A meeting of the ARGYLL AND BUTE LOCAL REVIEW BODY will be held in the COUNCIL CHAMBER, KILMORY, LOCHGILPHEAD on WEDNESDAY, 23 JANUARY 2013 at 3:10 PM, which you are requested to attend.

PROPOSED DEVELOPMENT AT THE CARDING MILL

(Argyll & Bute Ref 12/01588/PP)

GRANT OF PLANNING PERMISSION FOR CONVERSION OF EXISTING WORKSHOP TO FORM ANCILLARY DOMESTIC ACCOMMODATION AND FORMATION OF DECKING AREA AT, THE CARDING MILL, GALLANACH ROAD, OBAN

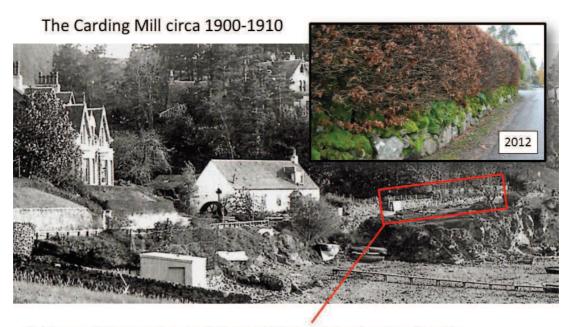
To establish the required visibility splays, we would be required to remove about 30 m of mature beech hedging towards Gallanach (see Figure 1) that is planted above an old dry stone wall (see Figure 2). A landscape gardener has advised us (Paradise Garden Services 07810 445898) that the removal of this hedging may indeed lead to the collapse of the existing dry stone wall, which is an historic element of the surroundings.

Establishing the required splays will require reduction in height of existing stone walls and the removal of mature planting (Figure 1); the effect being to substantially change the appearance of the frontage of an historic house in Oban and alteration of the character of this area. Further, the required works would significantly reduce privacy to the house and affect the safety of the amenity ground, which is partly enclosed by the beech hedge and incorporates a children's play area. Installation of any new fencing or hedge to restore some privacy or safety would cause further change to the local character of the area.

Figure 3: Aerial view of The Carding Mill showing visibility splays from proposed altered gateway to the property (in blue) and the potential enhanced visibility from Glenmore Road onto Gallanach Road (in yellow) that could be created.

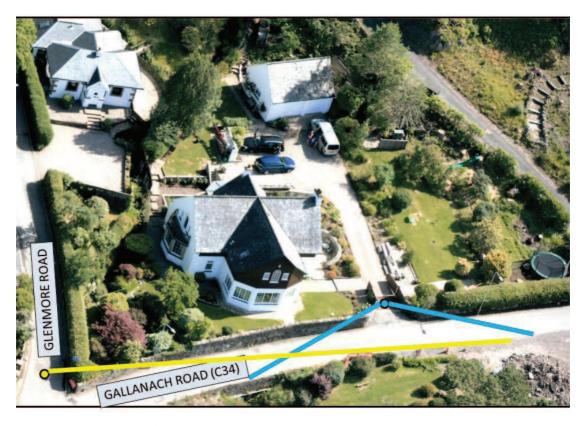
During the proposed development we had planned to renew the wooden gateways at the entrance and modify some of the stone work. We believe these changes would improve visibility significantly. Further, we have identified a part of our property where we can improve safety for all users where Glenmore Road accesses onto Gallanach Road. For details of these proposed changes please see technical appendix prepared by Mr J Tolmie and the schematic shown in Figure 3.

- I recommend that the works noted below are carried out to improve the safety of the existing access to The Carding Mill.
- a) To achieve visibility improvements towards Gallanach I would recommend that you lower the existing stone wall to a maximum height of 1.05 metres from the cattle grid round towards the mature beech hedge. This will give visibilities of 2.4 x 18 metres? while not affecting the hedge or the privacy/security of the children's play area.

- b) To improve the visibility towards the town I would suggest lowering the boundary wall over a distance of 6 metres which should give visibility in the order of 10 metres in that direction. Note that it will be necessary to alter or reduce the height of the pedestrian access gate. This will not impact on the privacy which is created by the higher boundary wall as that is not recommended for reduction in height.
